ADDENDUM

ADDENDUM NO.: #02

DATE: 02/08/2024

PROJECT: Woodhouse Ford Pro: Building Improvements

1 FLOOR PLAN - HVAC - AREA B
 1/8" = 1'-0"

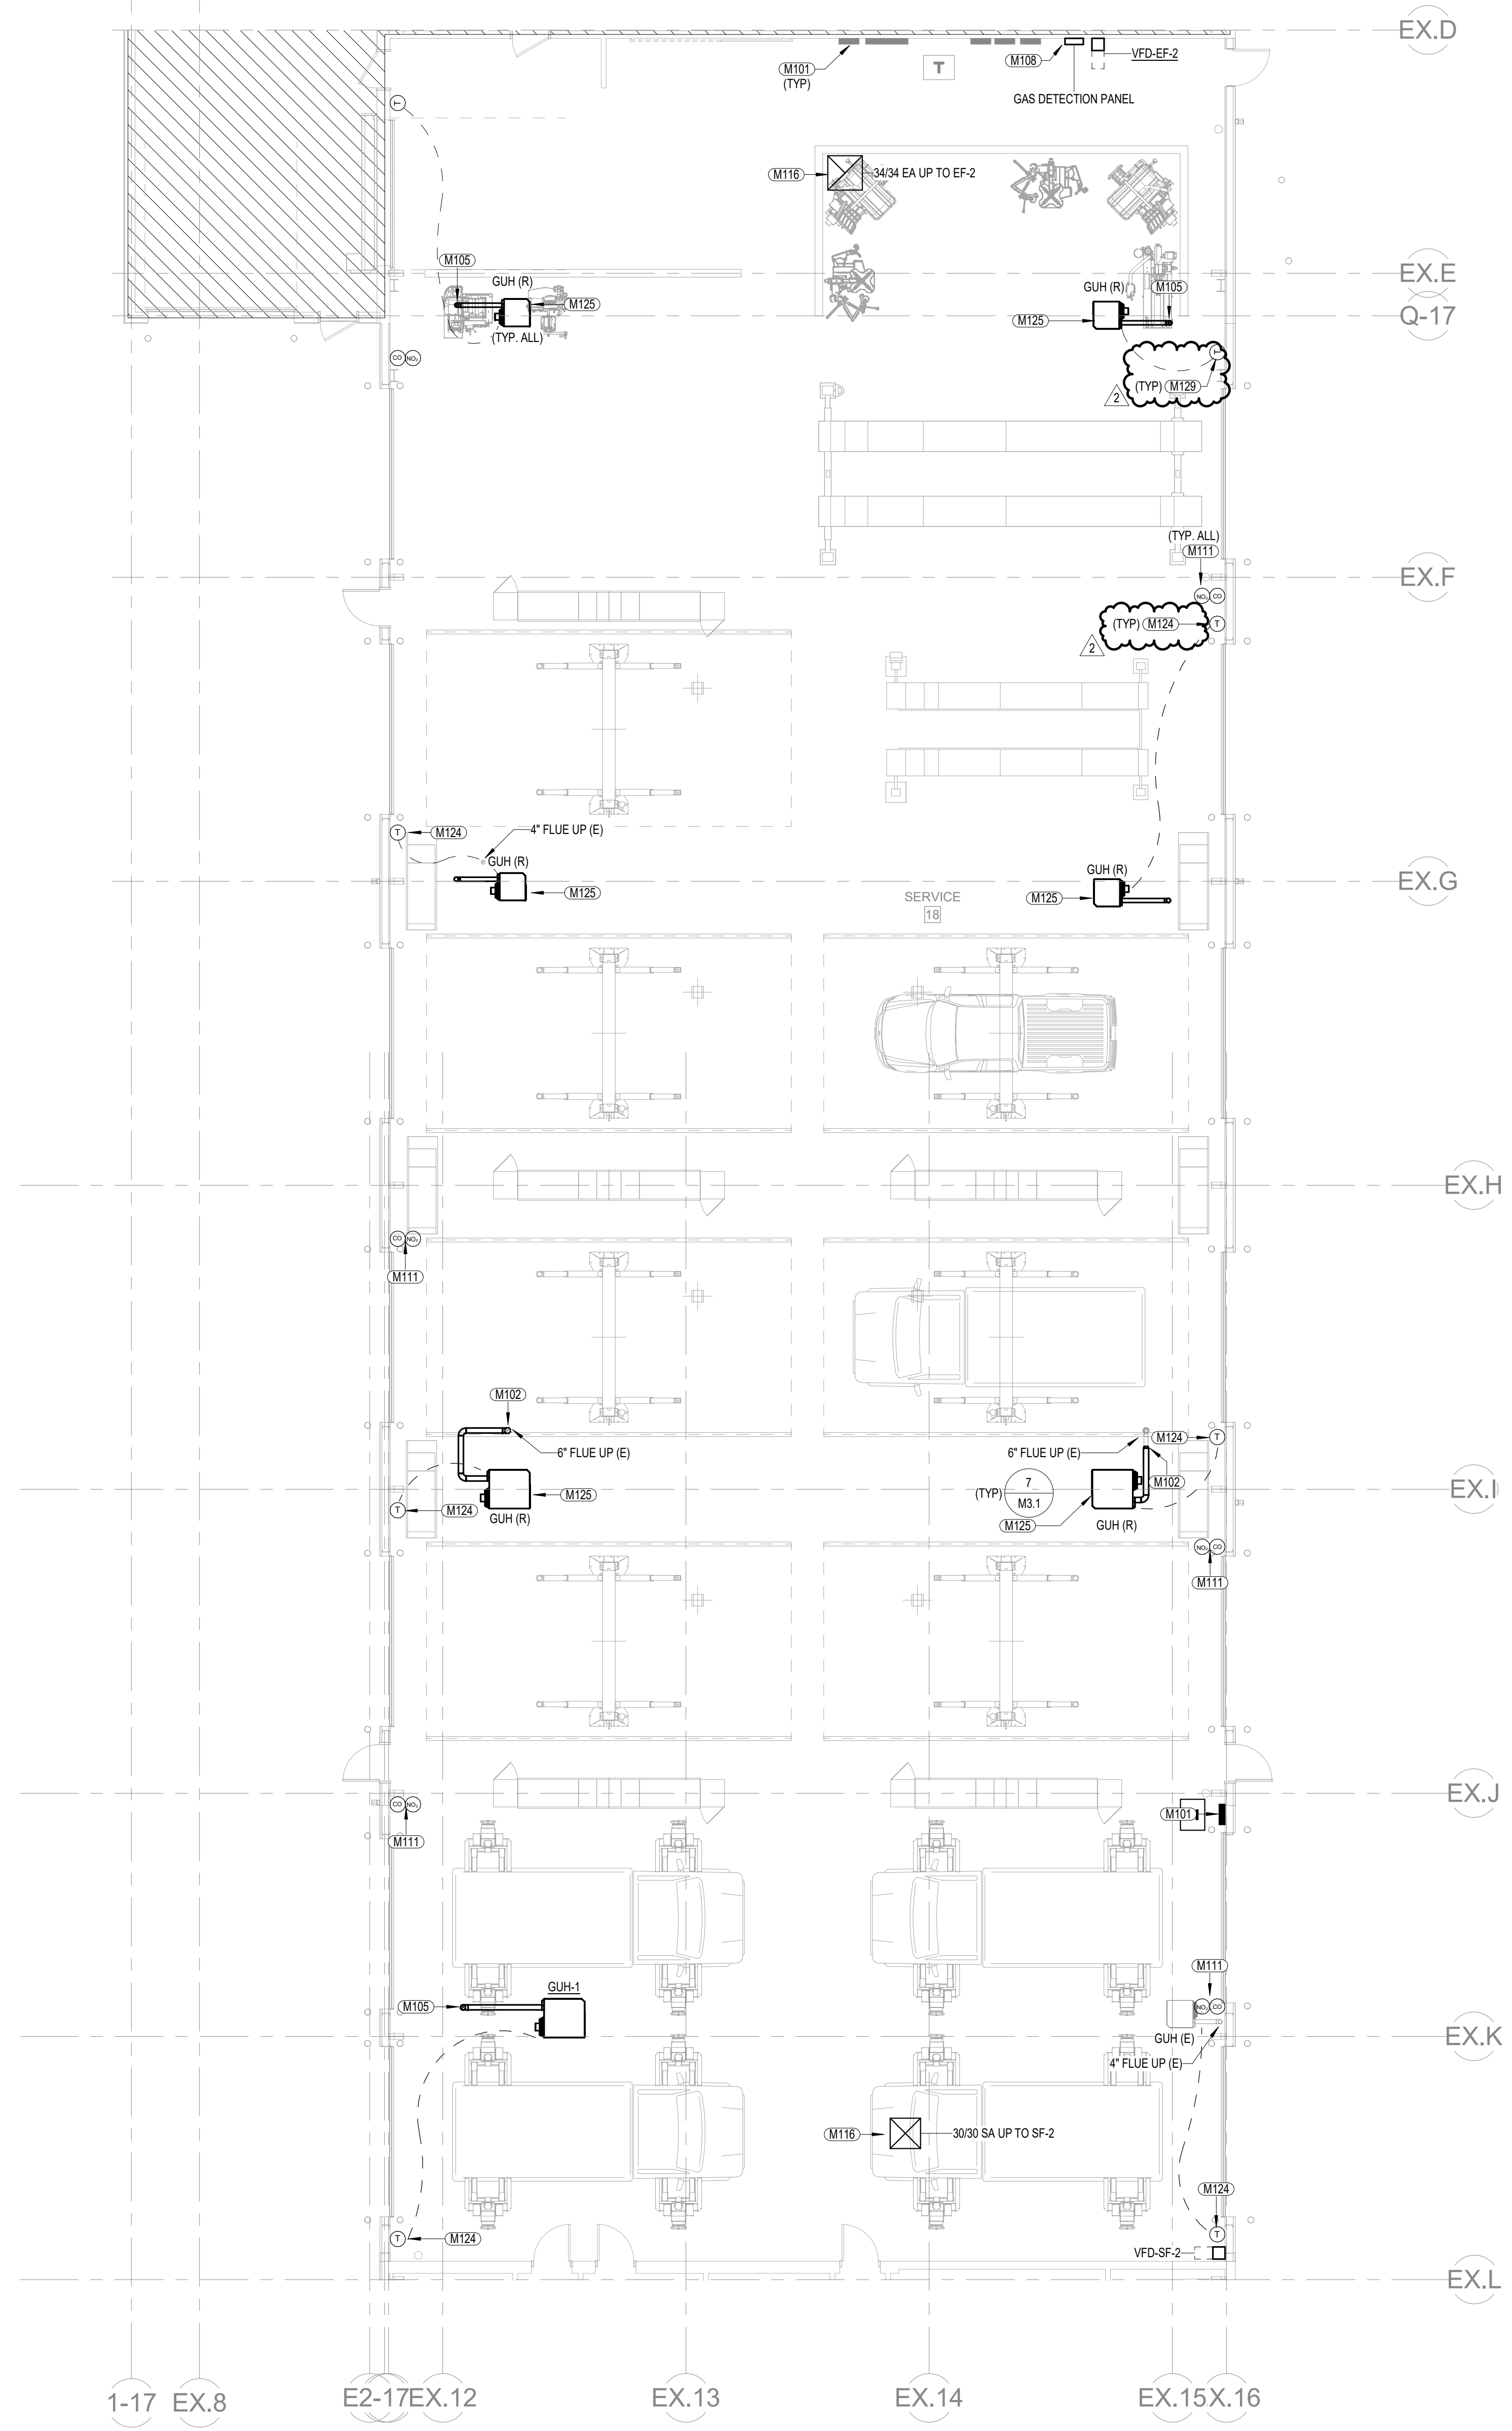
2. Sheet M1.2 – FLOOR PLAN – HVAC – AREA B
 - a. Revised notes for thermostats.
3. Sheet M1.3 – FLOOR PLAN – HVAC – AREA C
 - a. Revised notes for thermostats.

1 ROOF PLAN - MECHANICAL - AREA A
 1/8" = 1'-0"

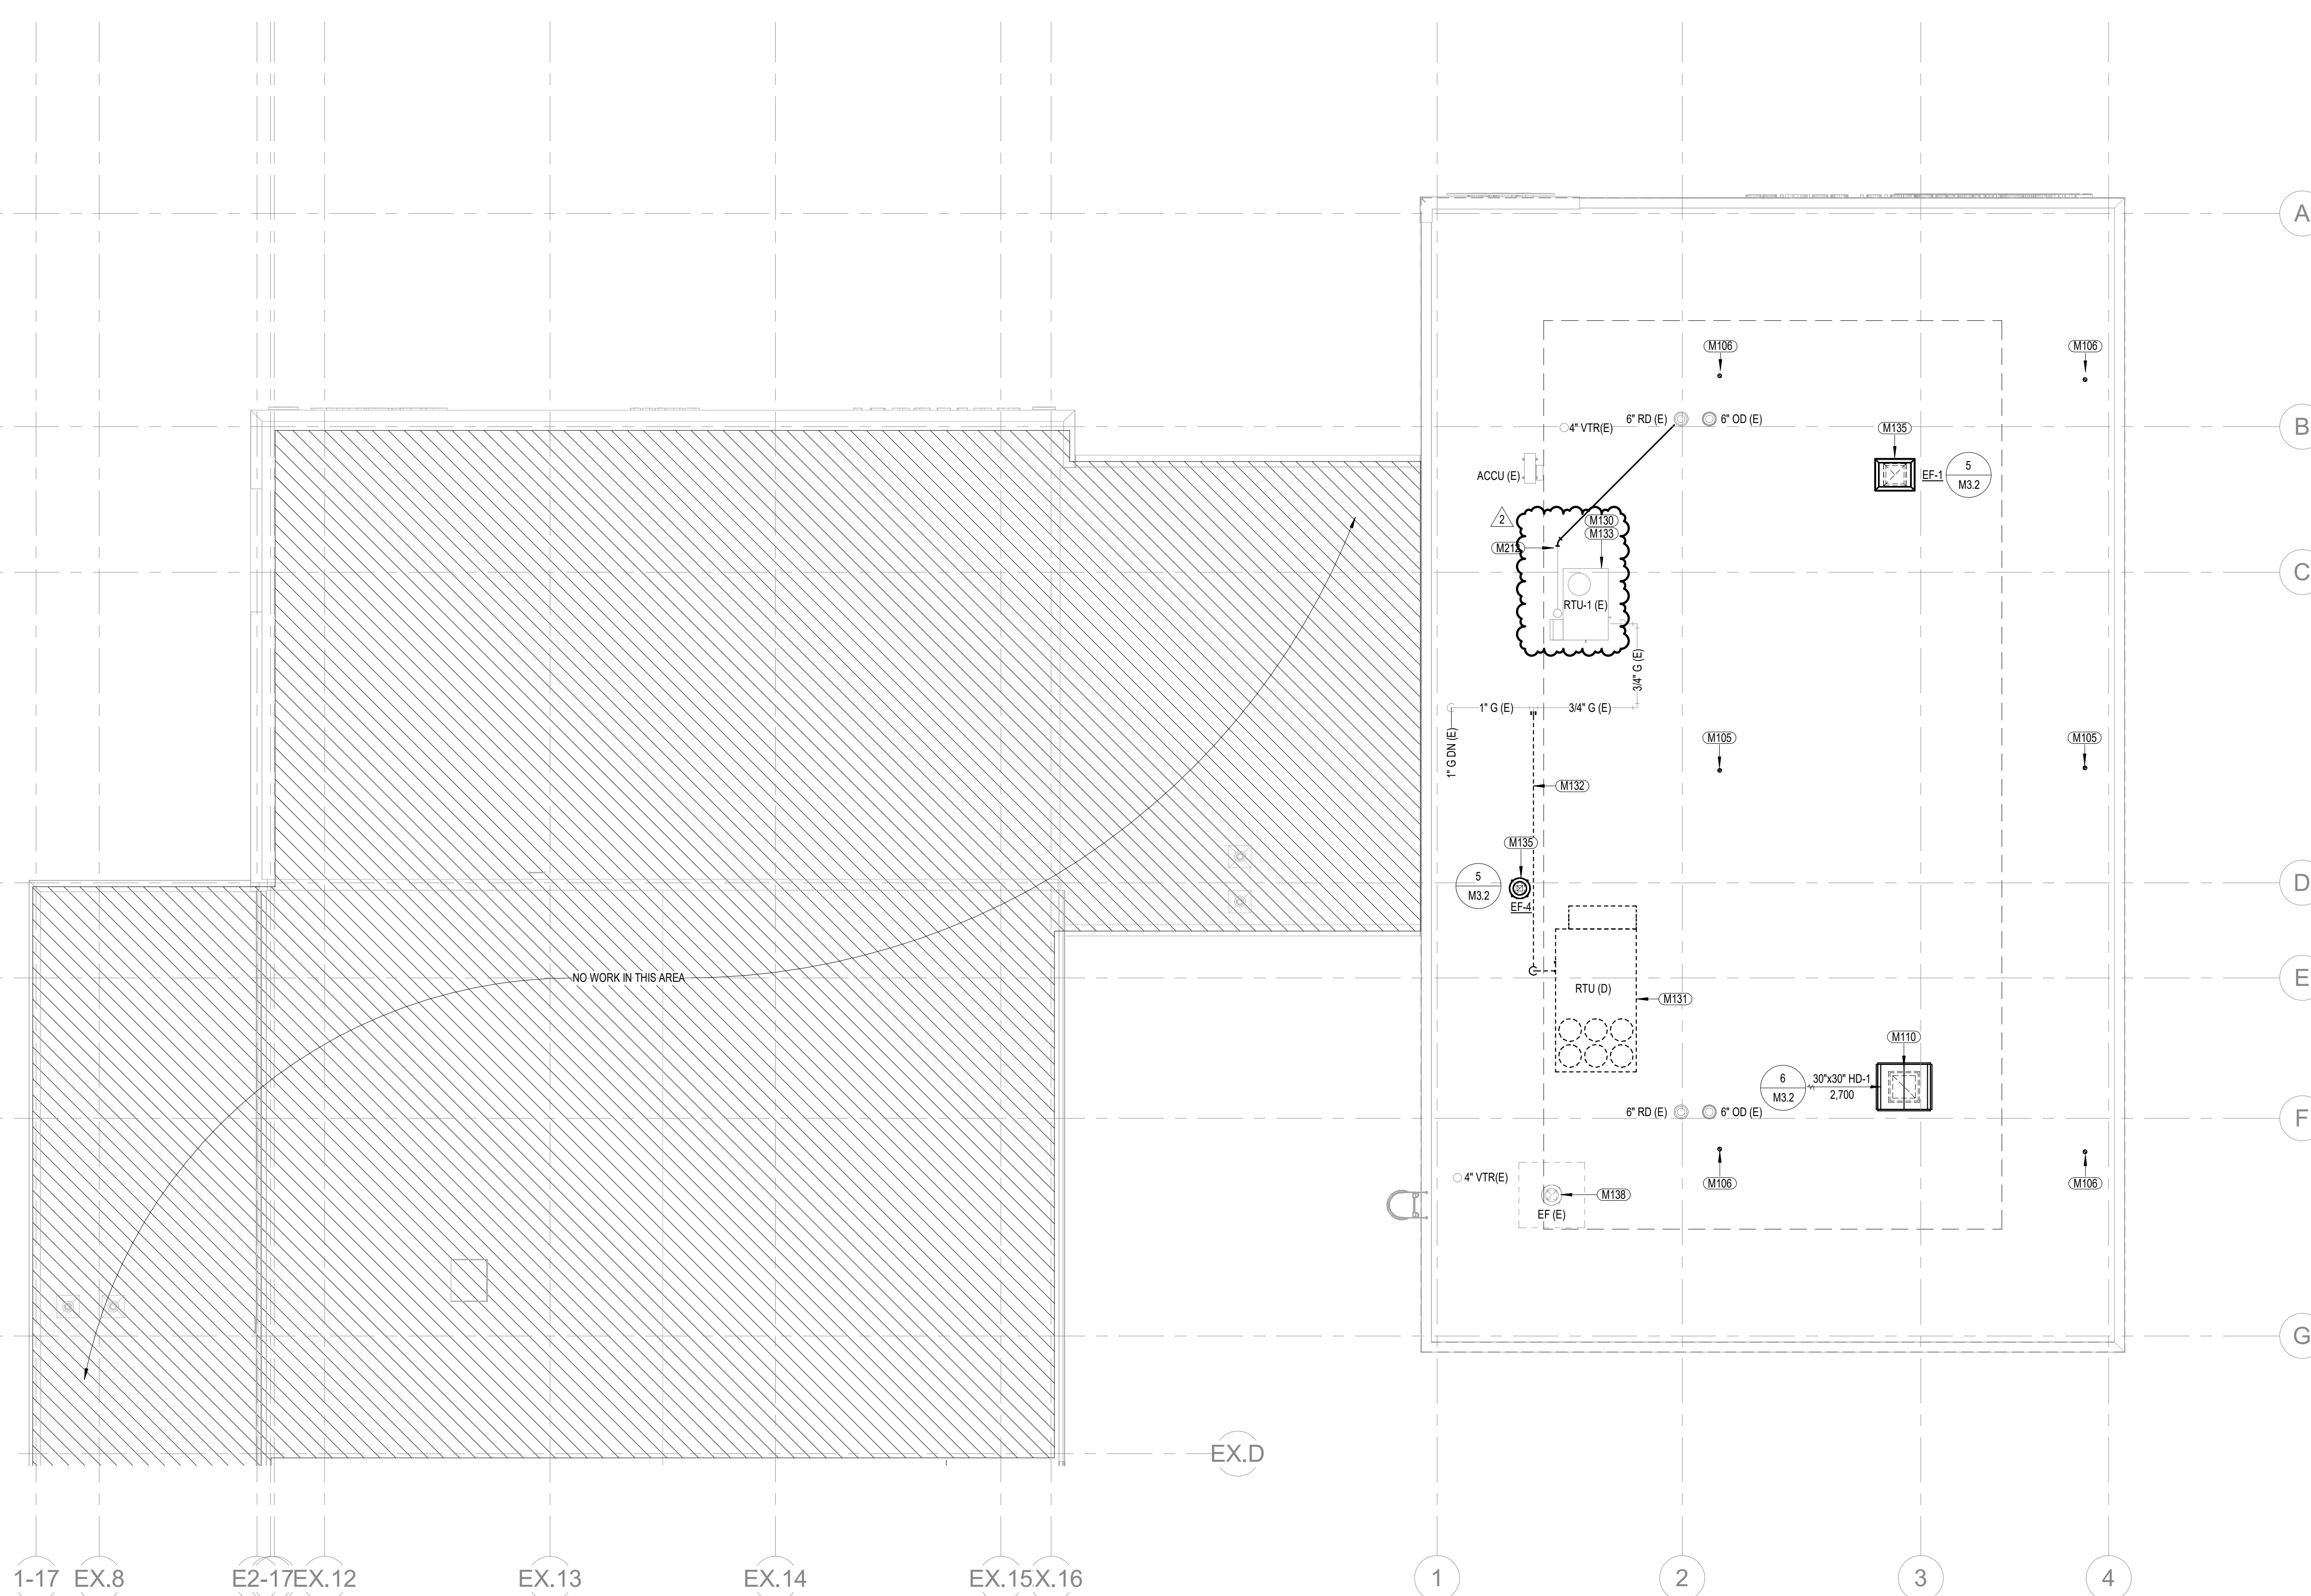
4. Sheet M1.4 – ROOF PLAN – MECHANICAL – AREA A
 - a. Add notes to RTU to provide new controller and VFD for supply fan.
5. Sheet M2.2 – UNDERGROUND PLAN – PLUMBING – AREA B

UNDERGROUND PLAN - PLUMBING - AREA B

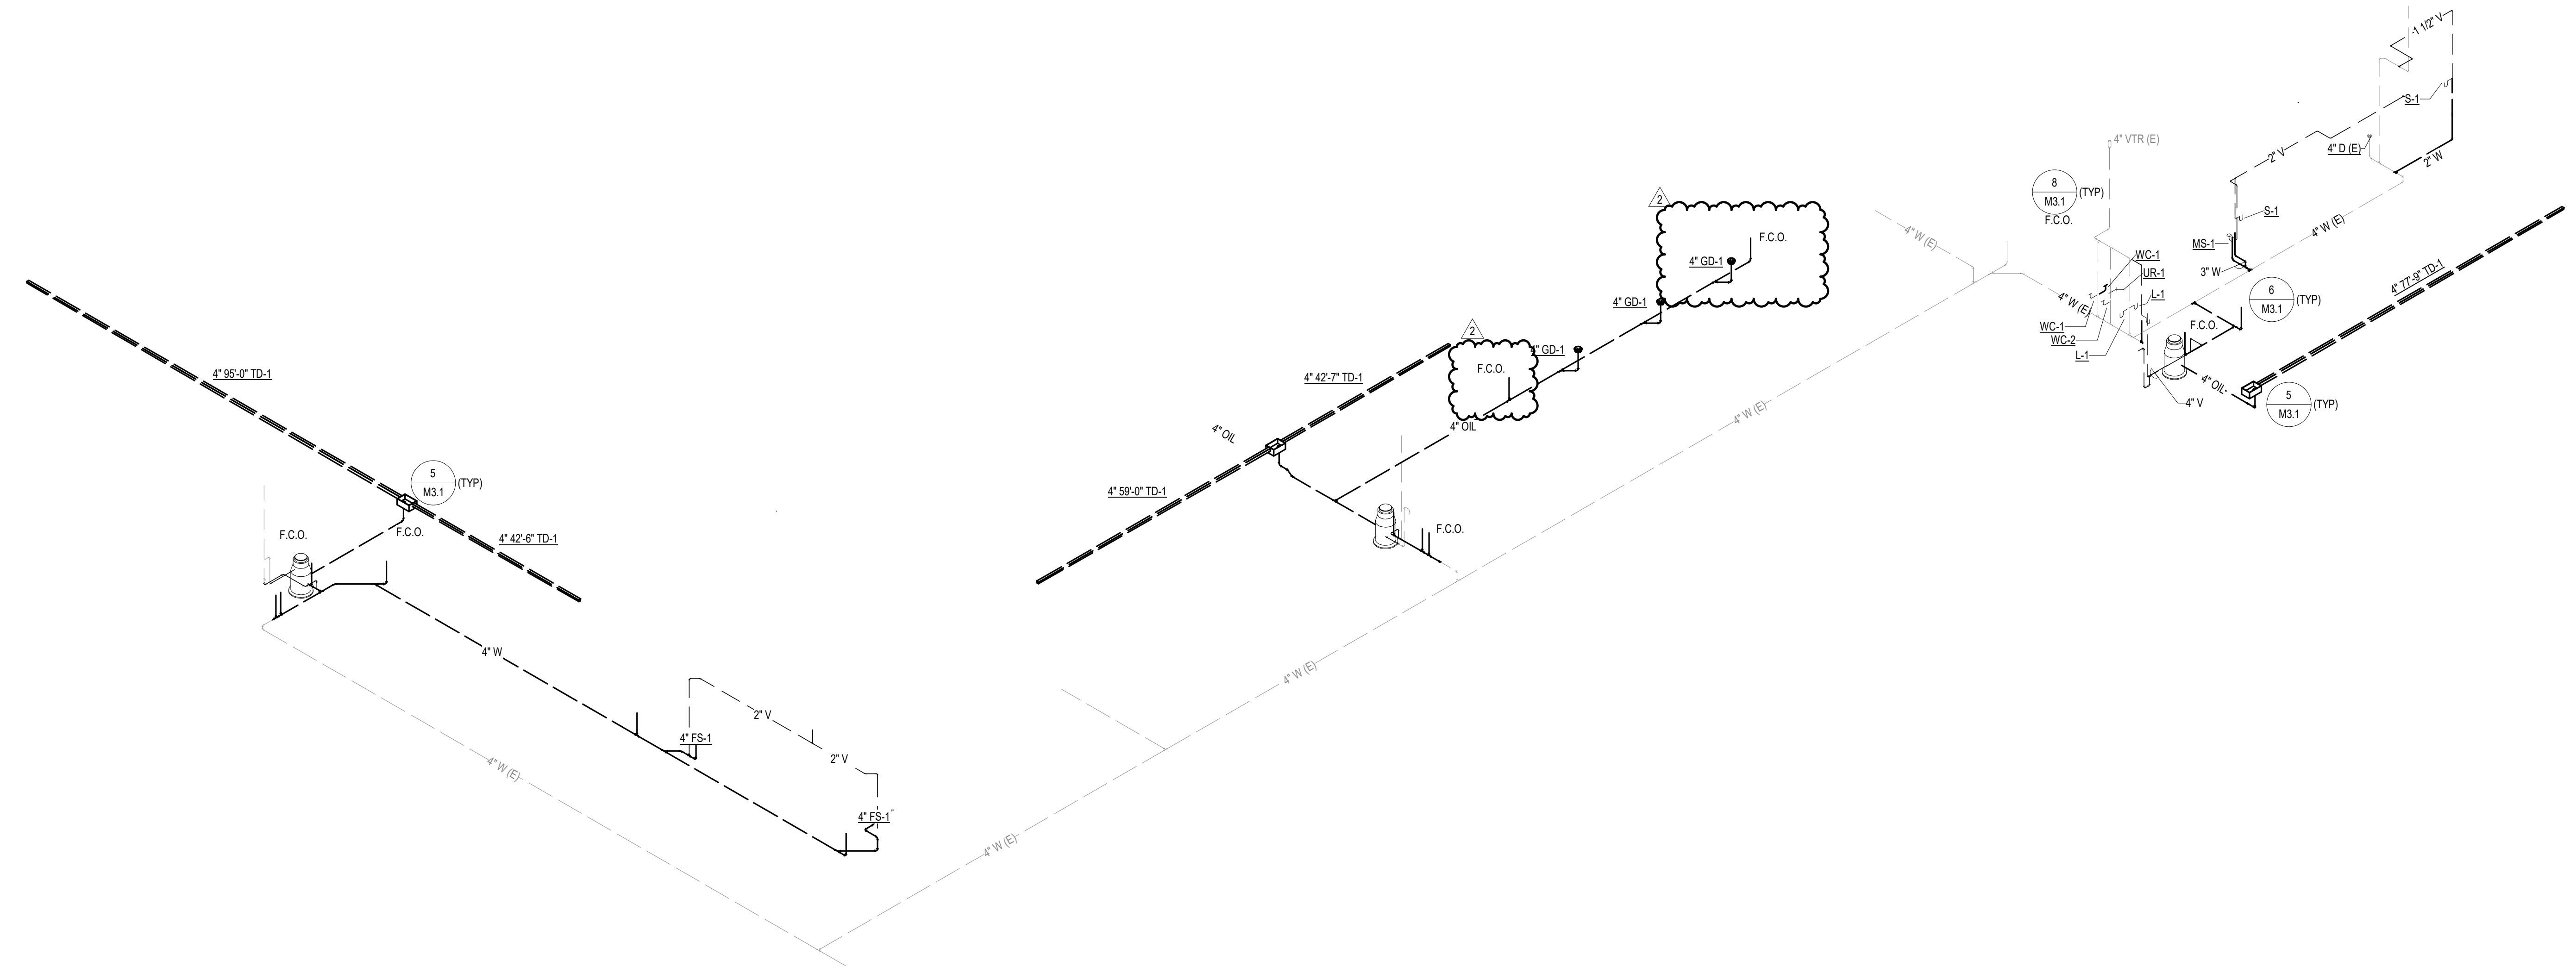
- a. Add floor drain.
 - b. Extend floor cleanout location.
 - c. Add additional floor cleanout.
6. Sheet M2.7 – FLOOR PLAN – PLUMBING – WASTE AND VENT RISER
